Access Compliance Report Public Rights-of-Way (Curb Ramps)

Main Street: STERLING_GLEN Cross Street: LANESBORO_RD Location: S

ADA ID: RPAT211101134437 Ramp Type: Type 4 - Parallel Initial Pass/Fail: Fail Overall Compliance: No Severity Score: 32

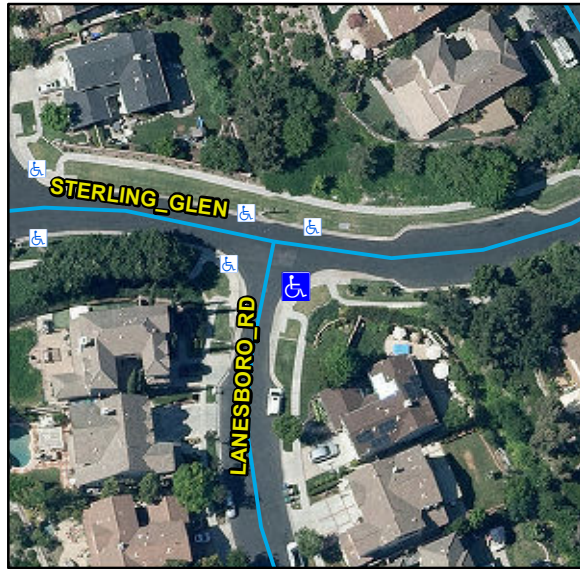
Compliance	Description	Data	Compliance	Description	Data
N/A	Ramp Length LT (in)	106	N/A	Ramp Length RT (in)	95
Yes	Ramp Width LT (in)	54	Yes	Ramp Width RT (in)	53
No	Ramp Run Slope LT (%)	12.7	Yes	Ramp Run Slope RT (%)	1.4
No	Ramp Cross Slope LT (%)	3	No	Ramp Cross Slope RT (%)	2.4
N/A	Landing Present	N/A	N/A	DWS Provided	N/A
N/A	Landing Length (in)	N/A	N/A	DWS Contrast	N/A
N/A	Landing Width (in)	N/A	N/A	DWS Length (in)	N/A
N/A	Landing Run Slope (%)	N/A	N/A	DWS Full Width	N/A
N/A	Landing Cross Slope (%)	N/A		DWS Offset Type	N/A
N/A	Landing Movement Obstructed?	N/A	N/A	DWS Offset Left (in)	N/A
	Landing Movement Type	N/A	N/A	DWS Offset Right (in)	N/A
N/A	Landing Shared	N/A			
N/A	Clear Space	Yes			
N/A	Clear Space To Crosswalk (in)	N/A			
N/A	Marked Crosswalk 1	No	N/A	Marked Crosswalk 2	No
	Crossing 1 Direction	NE		Crossing 2 Direction	NW
	Marked Crosswalk 1 Width (in)	N/A		Marked Crosswalk 2 Width (in)	N/A

N/A	Ramp Inside Crosswalk 1	N/A	N/A	Ramp Inside Crosswalk 2	N/A
	Crossing 1 Slope (%)	1		Crossing 2 Slope (%)	5.6
	Crossing 1 Cross Slope (%)	6.8		Crossing 2 Cross Slope (%)	2.6
N/A	Gutter Ponding	N/A	N/A	Curb Slope	13.2
Yes	Gutter Lip Height (in)	0		Road Run Slope (%)	6.3
N/A	Gutter Run Slope (%)	N/A		Road Cross Slope (%)	3.6
N/A	Gutter Cross Slope (%)	N/A	No	Perpendicular Joint Present	No
Yes	Overall Surface Condition	Acceptable			
	Cross Gutter Present?	No		Spandrel Present?	No
	Replace Cross Gutter?	N/A		Replace Spandrel?	N/A

Remove & Replace Curb Ramp With Two New Directional Ramps or Equivalent.

R204.3, R304.3.2, R304.5.3, STD 1115
